Flight Procedures Cover Page	Task Action: FLIGHT CHECK	Task Type: IAP	Estimated Chart Date: 10/05/2023	APWS Task ID: F90704DC7721448FB1D55FED378FB1A4	APWS Project ID: 40A74901475A4E01A3EB0A2236125E82
Procedure: COPTER RNAV (GPS) M 351 ORIG		Enroute: NO	Specialist: Melton, William		Agreement Number:
Airport ID: 1ME2			Airport City: WATERVILLE		State: ME
Facility ID:	Facility Type:	Flight Inspection Remark Type: New FC Slot

FIPC BASIC FORM							
PROCEDURE: COPTER RNAV (GPS) M 351 ORIG			AIRPORT NAME: MAINE GENERAL MEDICAL CENTER-		AIRPORT ID: K1ME2	SPECIAL CONTROL NO: YG-07-065-23	
FAC ID: 32468		CITY: WATERVILLE			ST: ME	ORIG CHART DATE: 11/30/2023	
DFL TYPE: PROC/H	THIRD PARTY: <input type="checkbox"/> YES	EST. TIME ON SITE: 0.5	REIMB. NUMBER:		PTS TASK ID: F90704DC7721448FB1D55FED378FB1A4		
PREFLIGHT NOTES							
REVIEWER:					DATE:		
COMMENTS:					CHECK ONE:		
					<input type="checkbox"/> FLT CK REQ <input type="checkbox"/> NFCR <input type="checkbox"/> REJECT		
							YES
					CPV COMPLETE?		X
PROCEDURE RESULTS							
INSPECTION DATE: 10/04/2023		CREW #: VN423	N #: HELO	INSTRUMENT PROCEDURE STATUS: <input checked="" type="checkbox"/> SAT <input type="checkbox"/> SAT W/CHANGES

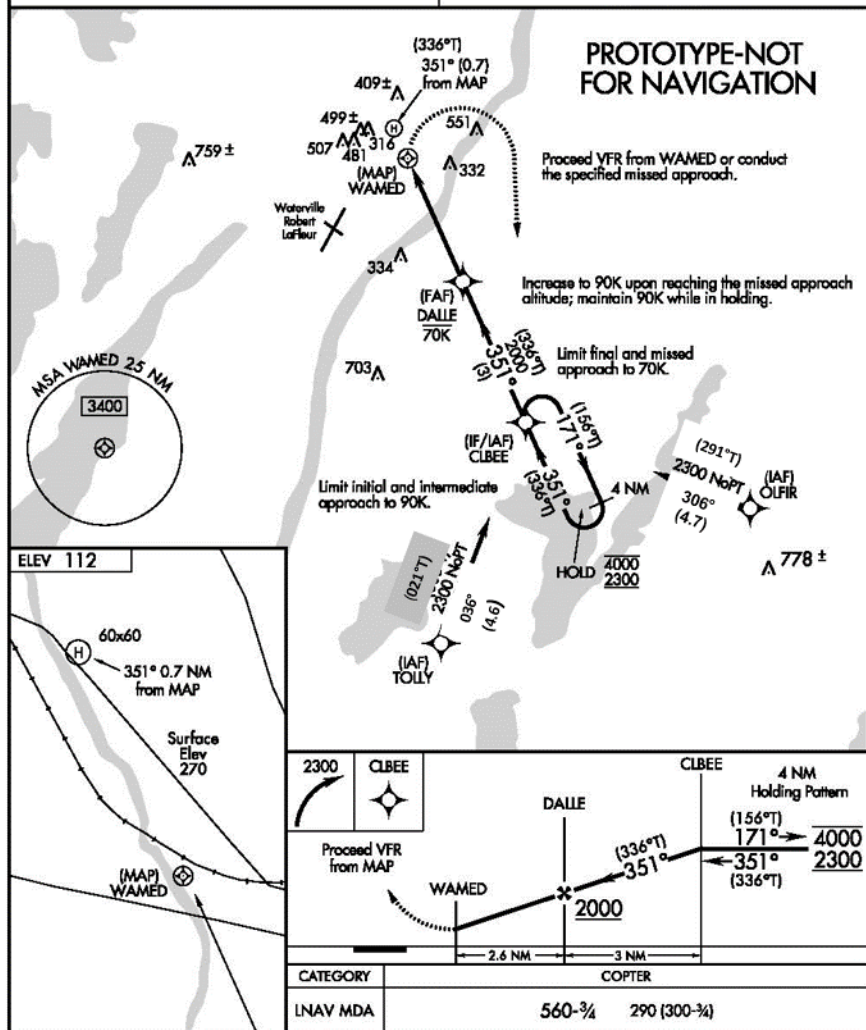
06/02/2023: THIS IS AN UPDATED COPY OF THE FORM DEVELOPED ON 05/01/2023.
1. PROCEDURE NAME CHANGED FROM M 336 TO M 351 - MAGVAR UPDATE.
2. CHANGED MAGVAR FROM 00W TO 15W - CORRECT ADMINISTRATIVE ERROR.
3. INCREASED ALL COURSES 15 DEGREES - MAGVAR UPDATE.
4. CHANGED ALTIMETER NOTE FROM USE WATERVILLE ALTIMETER SETTING TO USE WATERVILLE ALTIMETER SETTING; WHEN NOT RECEIVED, USE NORRIDGEWOCK ALTIMETER SETTING AND INCREASE MDA 60 FT - AIR AMBULANCE PROCEDURE AND MORE PRUDENT TO HAVE ALTERNATE ALTIMETER READILY AVAILABLE THAN VIA NOTAM.

Use of Maine General Medical Center-Waterville requires permission of the owner; use of this procedure requires specific authorization by FAA Flight Standards. Use Waterville altimeter setting, when not received, use Norridge altimeter setting and increase MDA 60 feet.
